TECHNICAL EVALUATION REPORT

RADIOLOGICAL EFFLUENT TECHNICAL SPECIFICATION IMPLEMENTATION (A-2)

INDIAN POINT NUCLEAR POWER PLANT UNIT 3

NRC DOCKET NO. 50-286

Figure 1. Liquid Radwaste Treatment Systems, Effluent Paths, and Controls for Indian Point Nuclear Power Plant Unit 3

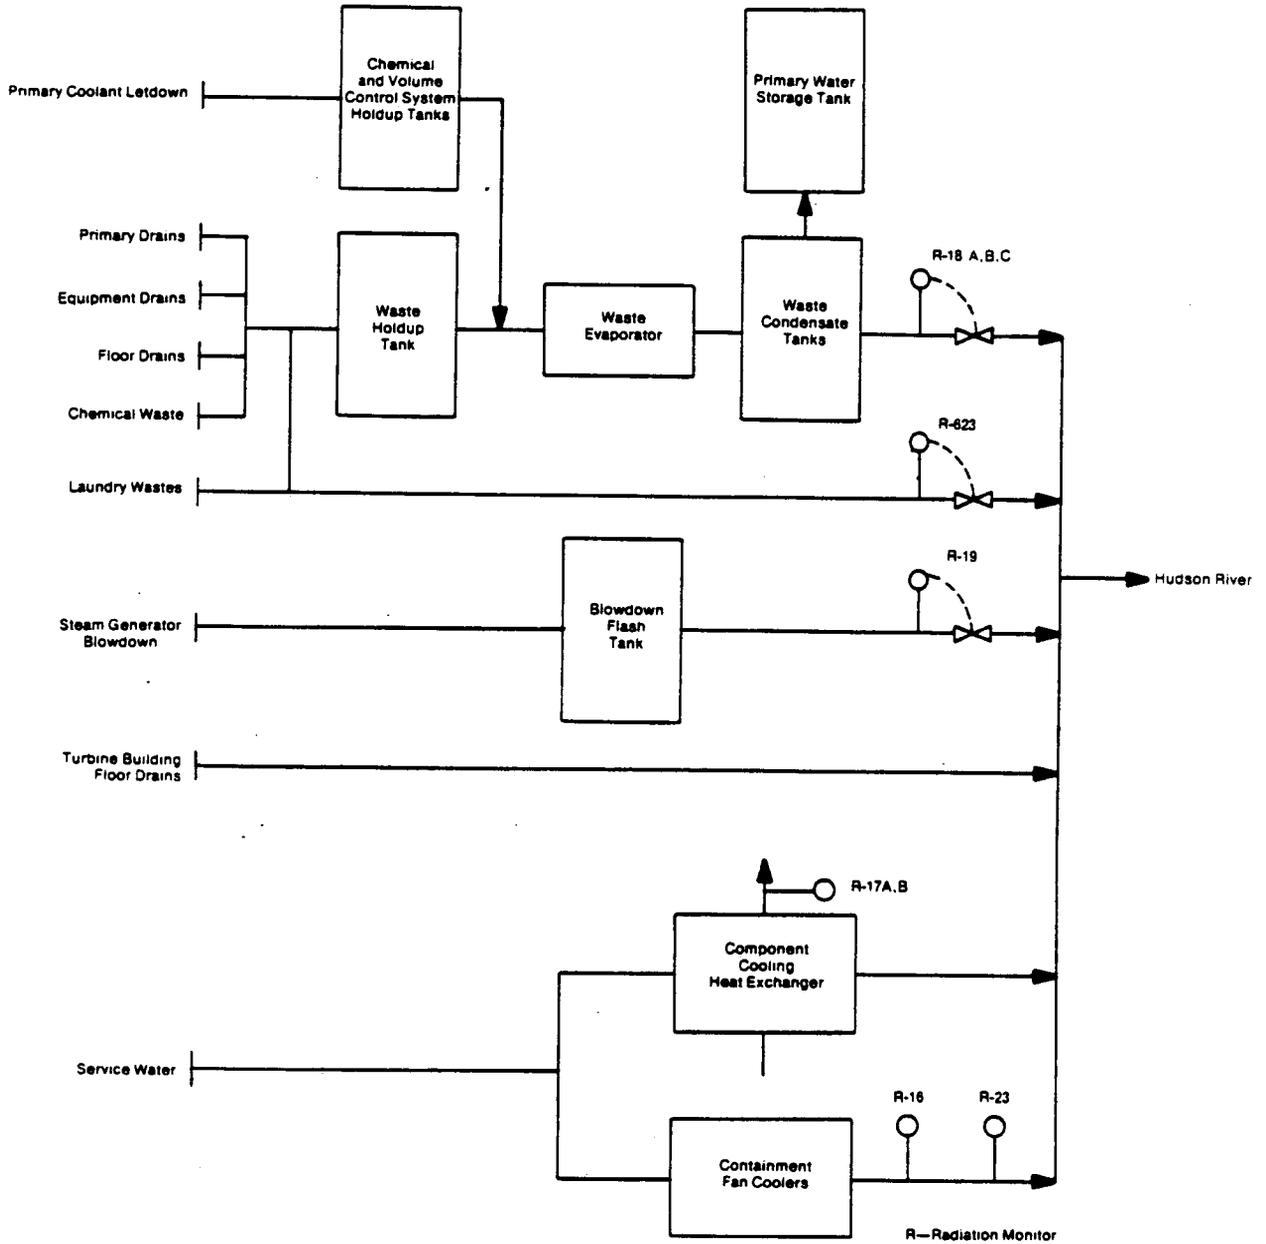
A diagram of the liquid effluent release paths indicating the location of the liquid effluent monitors is shown in Figure 1. The radioactive liquid wastes originating from the primary drains, equipment drains, floor drains, primary coolant letdown, and chemical wastes are processed through an evaporator prior to release. These wastes are monitored and controlled by the liquid radwaste effluent radiation monitor (R18). The steam generator blowdown waste effluents are monitored by the steam generator blowdown radiation monitor (R19) prior to being transferred to the blowdown flash tank. The laundry drains are transferred to the waste holdup tank if processing is required or they are discharged directly to the environment if radioactive concentrations are low. The laundry wastes are monitored by the laundry drains monitor (R-623). Potential leakage of radioactive material into the service water effluents is monitored by the containment fan coolers/service water line discharge monitors (R-16 and R-23). The turbine building floor drains are imbedded in the concrete foundation and are

therefore inaccessible and unmonitored. The floor drains are discharged to the environment without processing due to the normally low radioactive concentration in the turbine building sumps. As a safety measure, the liquid radwaste effluent radiation monitor (R18) and the steam generator blowdown line radiation monitor (R-19) are provided with automatic termination of release upon a high concentration alarm signal.

Figure 2. Gaseous Radwaste Treatment Systems, Effluent Paths, and Controls for Indian Point Nuclear Power Plant Unit 3

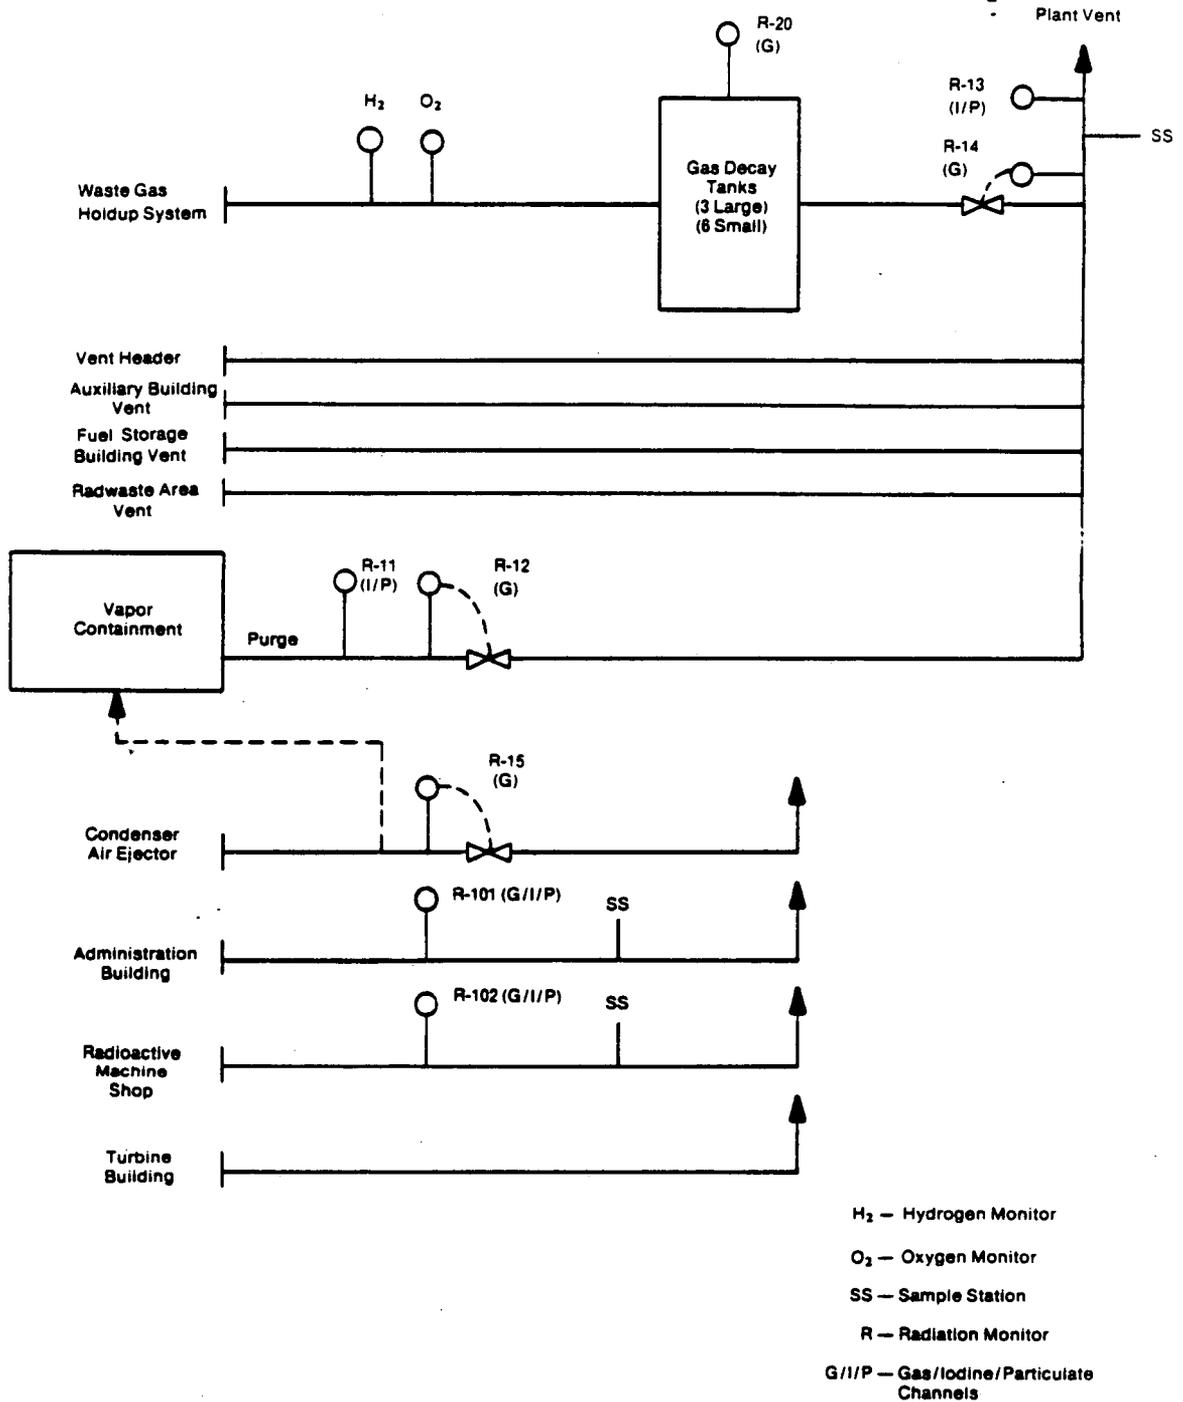
A diagram of the radioactive gaseous effluents indicating the location of radioactive gaseous effluent monitors is shown in Figure 2. Indian Point Unit 3 has a plant vent that is a combined release point for the major sources of gaseous effluents from the plant. There are several other rooftop release points, as shown in Figure 2. Wastes originating from the following sources are discharged through the plant vent: waste gas holdup system, containment vent and purge, condenser air ejector, vent header, and the ventilation exhaust from the auxiliary building vent, fuel storage building vent, and the radwaste area vent. The plant vent effluent release point is provided with particulate (including iodine-131) and noble gas effluent monitors (R-13 and R-14). The noble gas monitor (R-14) provides alarm and automatic termination of release for effluents from the waste gas holdup system. The waste gas holdup system is equipped with hydrogen and oxygen monitors to prevent the possibility of explosive gas mixture concentrations in the waste gas decay tanks and with a process monitor (R-20). The containment purge discharge is monitored by the containment gas monitor (R-12) with automatic termination of release on high alarm and the condenser air ejector monitor (R-15) with automatic diversion of release to the containment on high alarm. Radioactive

releases from the administration building ventilation exhaust and from the radioactive machine shop ventilation exhaust are monitored by noble gas/iodine/particulate radiation monitors (R-101 and R-102, respectively). The turbine building ventilation is normally released without monitoring.
